RE: S/D 99-61 -- Revised Final Plat of FIRST ADDITION TO BENTLEY FARMS ADDITION

At the regular meeting of the Subdivision Committee of the Metropolitan Area Planning Commission on Thursday, February 17, 2000, the above captioned plat was considered. The action of the Committee was to approve the final plat, subject to:

**STAFF REPORT**

**CASE NUMBER:** S/D 99-61 -- FIRST ADDITION TO BENTLEY FARMS

**VICINITY MAP**

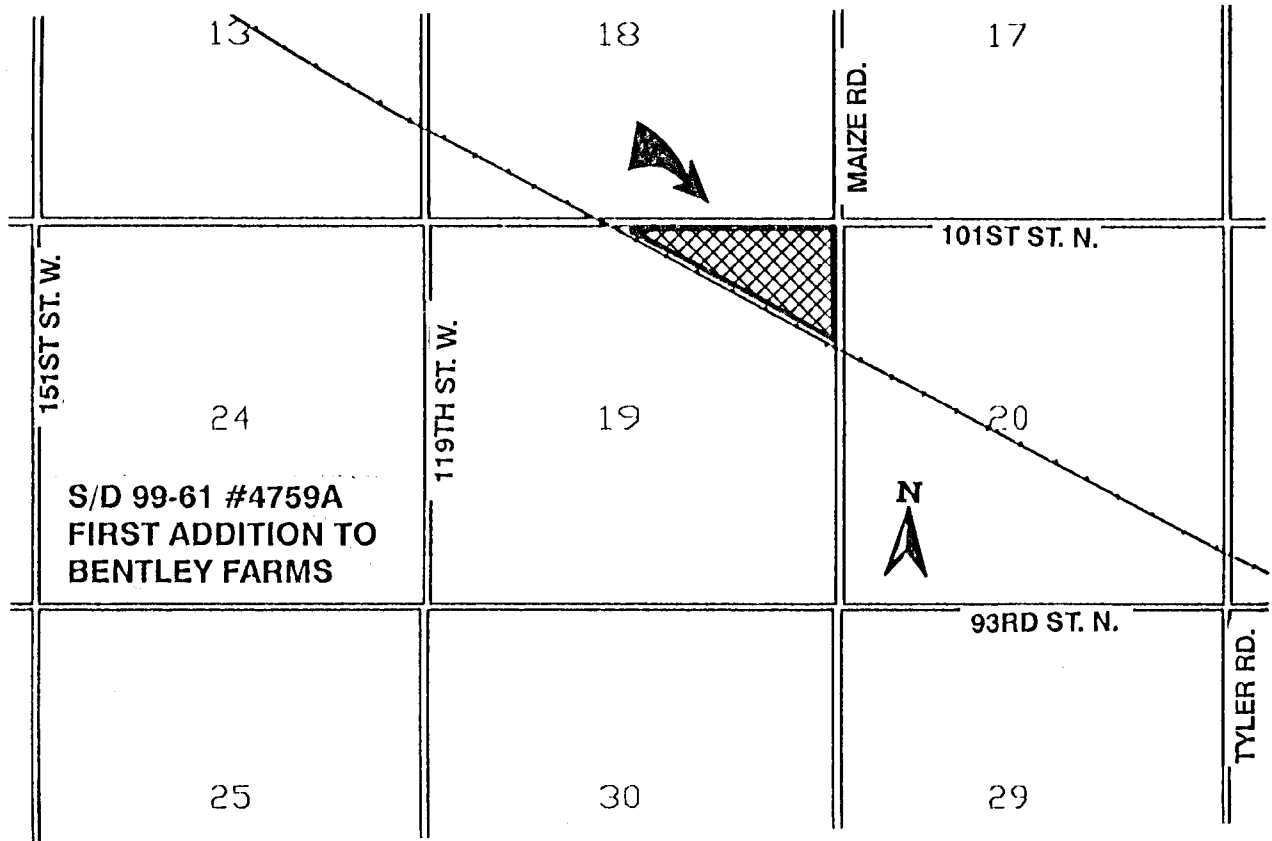
**Note:** This site is located in the County in an area designated as "agricultural" by the Wichita-Sedgwick County Comprehensive Plan. Lot developments of this type are contrary to the intent of the Comprehensive Plan; however, the MAPC and County Commission have chosen not to create an Agricultural Zoning District to protect against this type of development. This final plat has three fewer lots than the approved preliminary plat in order to accommodate the use of sewage lagoons.
